**UNITED STATES  
NUCLEAR REGULATORY COMMISSION**

**SUBJECT: CLINTON POWER STATION - FINAL SIGNIFICANCE DETERMINATION OF A WHITE FINDING WITH ASSESSMENT FOLLOW-UP AND NOTICE OF VIOLATION; NRC INSPECTION REPORT NO. 05000461/2018092**

## Final Significance Determination

Figure 1: Loss of Offsite Power (LOOP) Event Tree

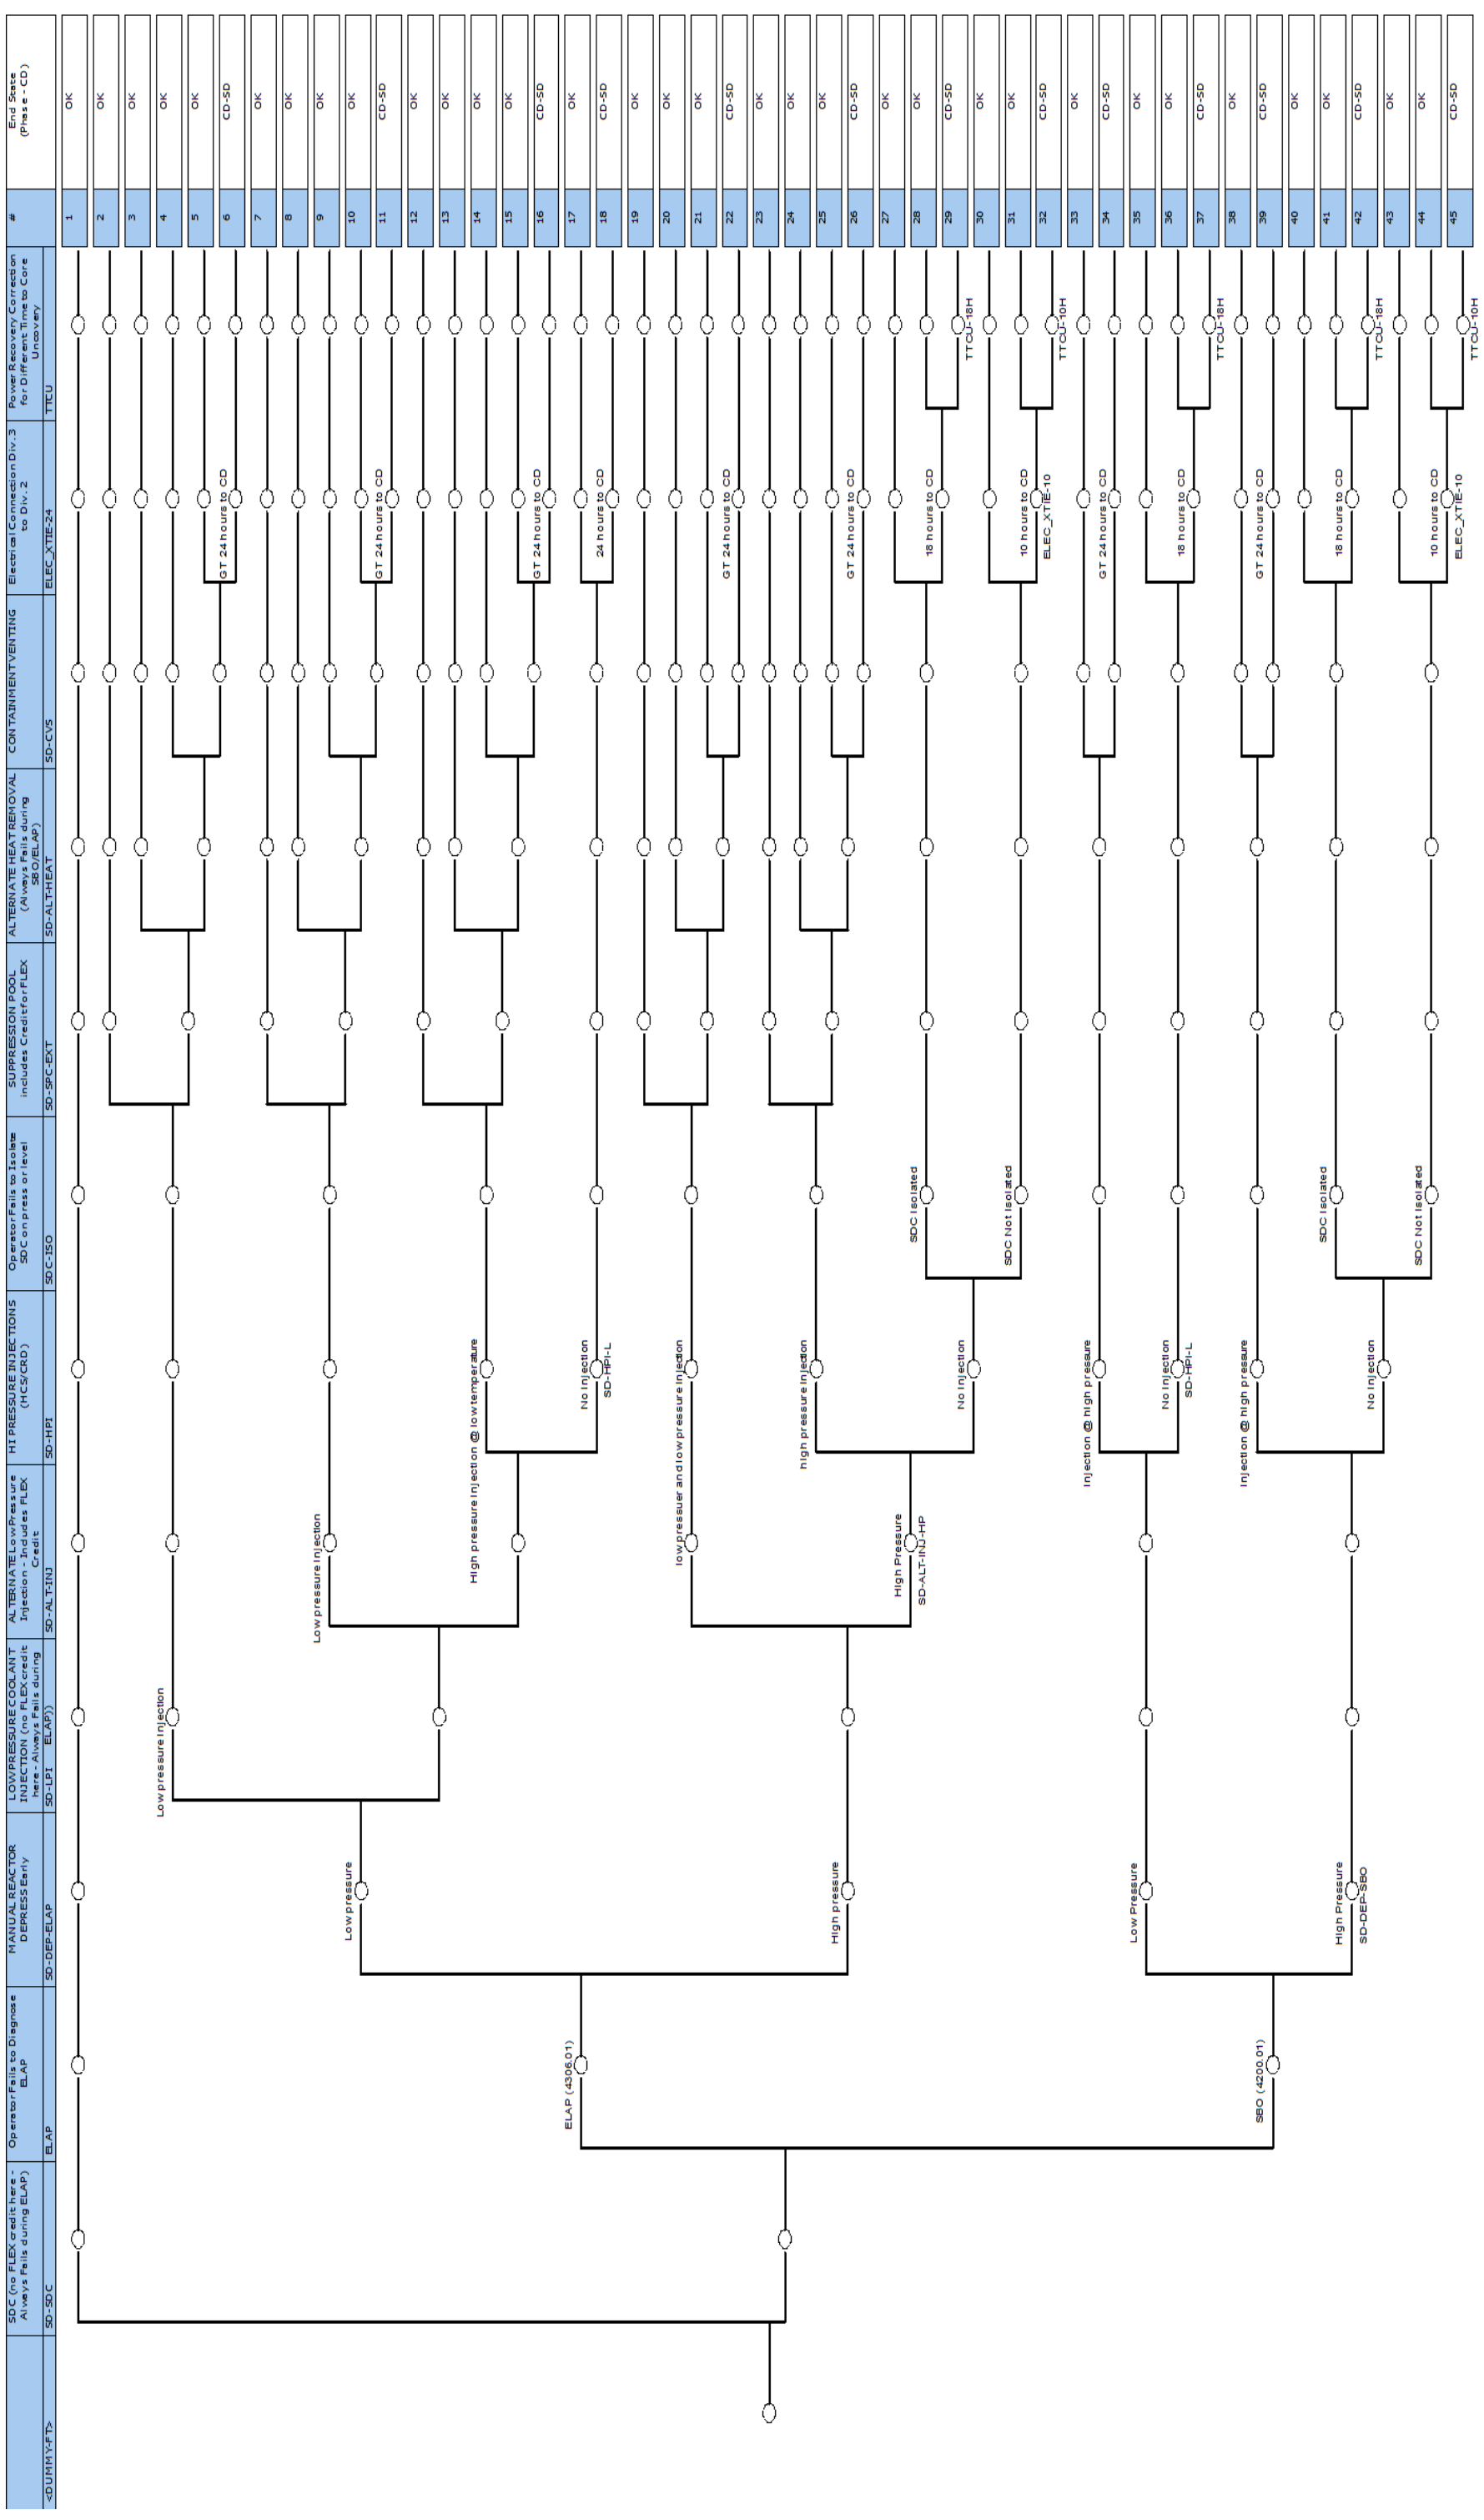
The new information led to changes to the event tree (ET) structure used to quantify the risk. This ET is shown in Figure 1 below. The top two dominant core damage sequences were Sequences 18 and 37. Sequence 18 includes: LOOP initiates, failure of the emergency diesel generators (EDG), failure to recover either of the two EDGs and offsite power, successful ELAP diagnosis, successful early reactor depressurization, failure of low pressure injection (including FLEX), failure of high pressure injection, and failure of the Division 3 to Division 2 cross-tie. Sequence 37 includes: LOOP initiates, failure of the EDG, failure to recover either of the two EDGs and offsite power, failure to diagnose ELAP, successful early reactor depressurization, failure of high pressure injection, failure to perform the cross-tie.

Based on the above understanding, the NRC concluded that its PRA modeling approach to declaring ELAP is reasonable and realistic. However, the NRC's PRA model was modified to test the assumption that operators declare an ELAP or remain in the station blackout procedure. The modified ET is shown in Figure 1. A new top event was added to the model as a decision point. If the decision is made to declare ELAP and enter the FLEX procedures, then the FLEX strategies are then tested. If the FLEX strategies fail, then the cross-tie is questioned.

To incorporate this new information, the NRC modified its risk analysis by adding a new event tree (ET) top event that tested for failure to isolate the RHR/SDC system from the RCS on high reactor pressure and decreasing reactor level. The modified ET is shown in Figure 1. This top event was evaluated using a new fault tree (FT). The FT tests for all three cues discussed above.

The event tree (see Figure 1) tests for successful depressurization. If depressurization is successful, then time to core uncover is extended allowing additional time for subsequent mitigation actions.

After considering the information provided by Exelon, the NRC staff made changes to the detailed risk evaluation regarding recovery of the diesel generator, battery life, the isolation of the shutdown cooling and pressure control without injection. The NRC also modified the event tree to model declaration of ELAP and entry into FLEX strategies vs. remaining in the station blackout procedure.

For the revised risk model, if ELAP is not declared, the FLEX strategies are not implemented. In this case, the risk evaluation models the use of the crosstie. If the crosstie is not successful and offsite AC power is not recovered, then core damage is assumed. FLEX is not considered further in this part of the risk model for two reasons. First, there is no procedural direction to try FLEX in the crosstie procedure. Second, if the crosstie has failed, significant issues may have occurred because of the failure. The cross-tie procedure (CPS 4303.01P023) twice reiterates safety considerations that state in part "Steps in this procedure must be performed in order to avoid the risk of personnel injury or equipment damage." The cross-tie procedure would not be exited unless it had failed and per the caution, failure implies damage to the electrical distribution system that is required to implement the FLEX strategies.
